F.1.a.a -161-167 Robertson Street: Development Variance Permit Application No. 00255 (Gonzales)

Committee of the Whole Report For the Meeting of March 11, 2021

To: Committee of the Whole **Date:** February 25, 2021
From: Karen Hoese, Director, Sustainable Planning and Community Development
Subject: Development Variance Permit Application No. 00255 for 161-167 Robertson Street

Original Basement Plan
SCALE 1 : 100

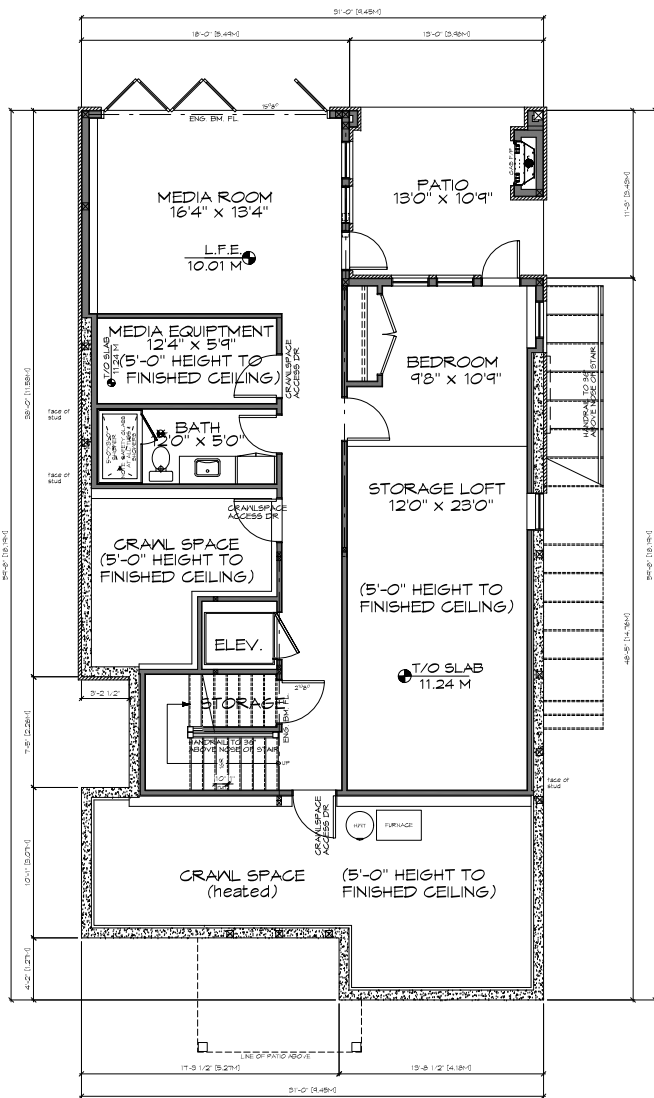
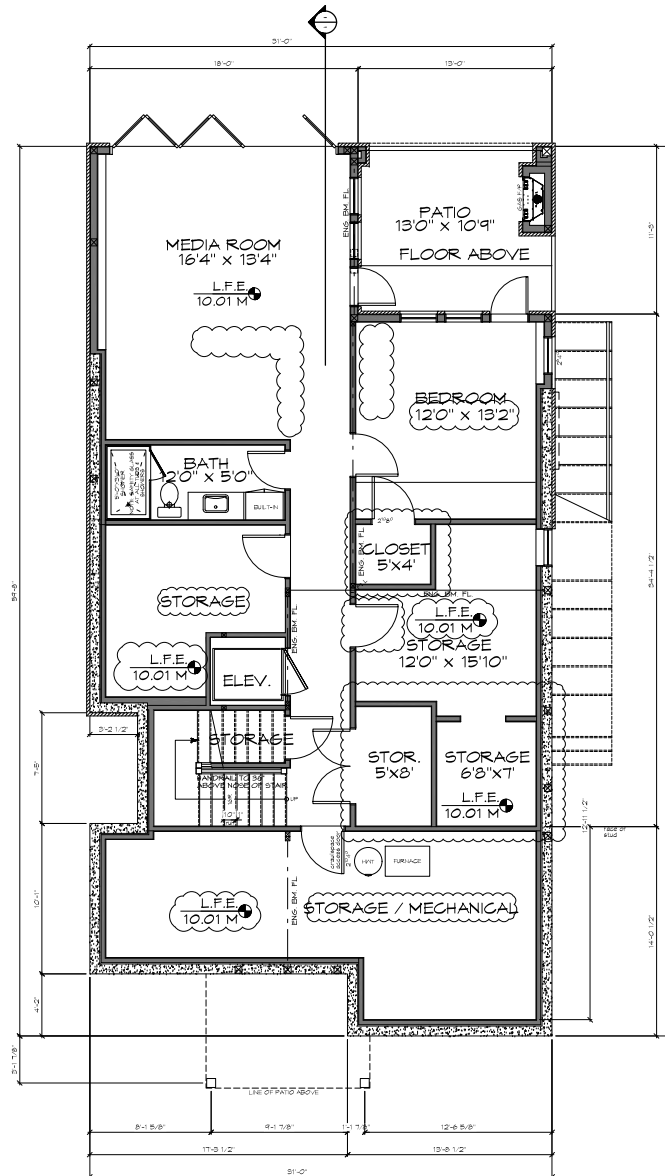
<u>BASEMENT</u>		132.83 M ² (1424.81 FT ²)	FORMERLY 60.03 m ² (646.2 FT ²)
<u>TOTAL FLOOR AREAS</u>		225.77 M ² (2439.14 FT ²)	variance required
<u>MAIN AND UPPER FLOORS</u>		300 M ² (3224.17 FT ²)	
<u>ALL FLOORS COMBINED</u>		300 M ²	
<u>FLOOR AREA RATIO</u>	0.50	24.82%	
<u>SITE COVERAGE</u>	50.00%	50.00%	all buildings
<u>OPEN SITE SPACE</u>	50.00%	50.00%	all buildings, structures and driveway
<u>OPEN SITE SPACE - FRONT YARD</u>		50.00%	all buildings, structures and driveway
<u>PARKING</u>	1	3	
<u>ACCESSORY GARAGE</u>			
<u>MUST BE IN REAR YARD</u>			
<u>REAR YARD</u>			
<u>SETBACKS</u>			
<u>TO HOUSE</u>	2.40 M	15.02 M (49.28')	variance granted 10/15/18
<u>REAR</u>	0.60 M	49.46 M (162.40')	
<u>SIDE NORTH</u>	0.60 M	0.61 M (2.00')	
<u>SIDE SOUTH</u>	0.60 M	6.40 M (21.00')	
<u>AVG. GRADE</u>		13.12 M (43.04')	
<u>BUILDING HEIGHT</u>	3.50 M	3.43 M (11.25')	
<u>FLOOR AREA</u>	37.00 M ²	36.76 M ² (395.71 FT ²)

REQUESTED VARIANCE INDICATED BY SYMBOL
